SCREW, MACHINE - DOUBLE HEXAGON EXTENDED WASHER HEAD, DRILLED, PD SHANK, SILVER PLATED, CORROSION AND HEAT RESISTANT STEEL, UNS S66286, 130 KSI MIN, .1640-36 UNJF-3A

AS9573™
SHEET 1 OF 2

REV. D

FIGURE 1 - SCREW

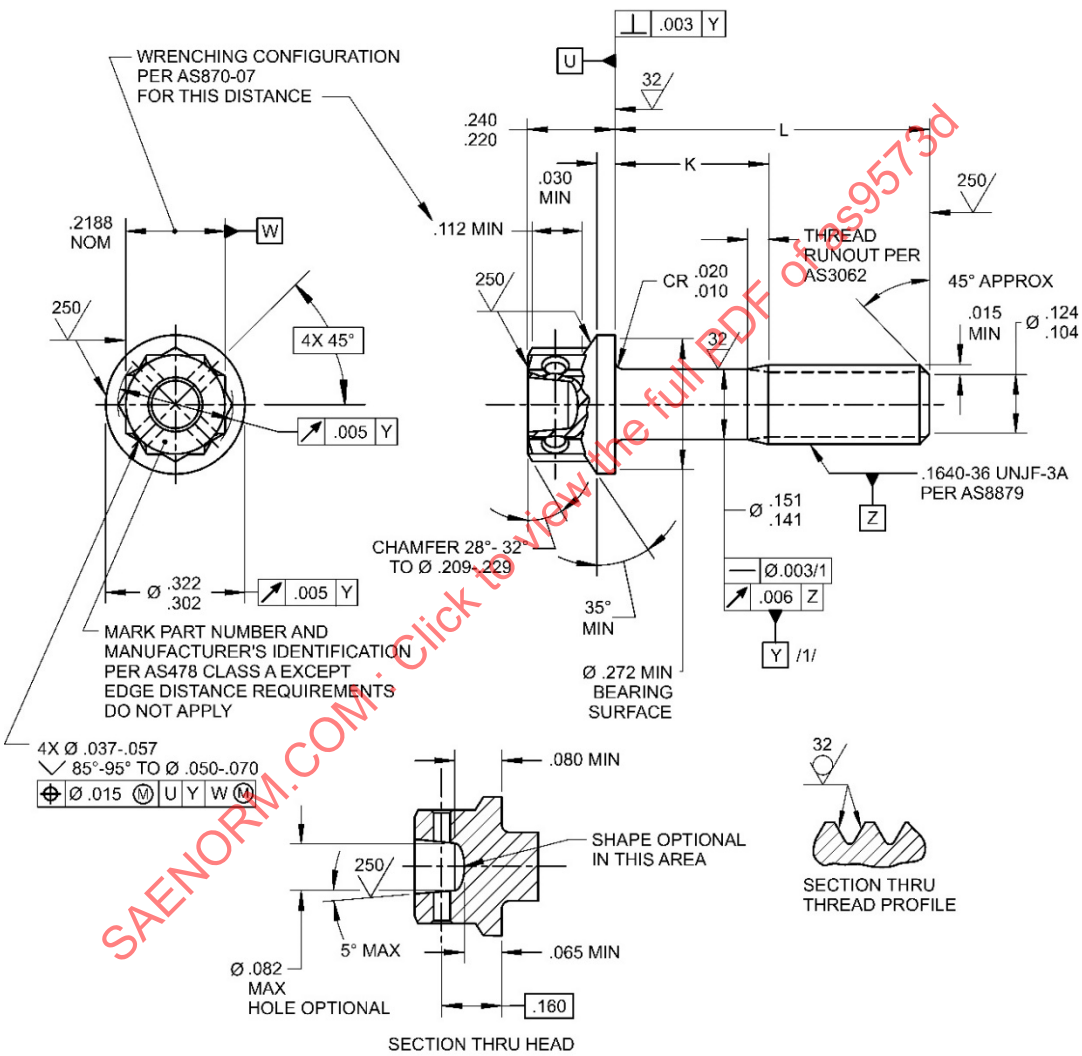
FIVE-YEAR REVIEW. UPDATE TO ASME Y14.5-2018. REVISE HEAD TO SHANK FILLET RADIUS TO "CR." REVISE LEAD THREAD CHAMFER TO AS1132. DELETE RFS SYMBOL FROM SHANK STRAIGHTNESS FEATURE CONTROL FRAME. IN NOTE 2, ADD "COMPOSITION SIMILAR TO" BEFORE UNS NUMBER.
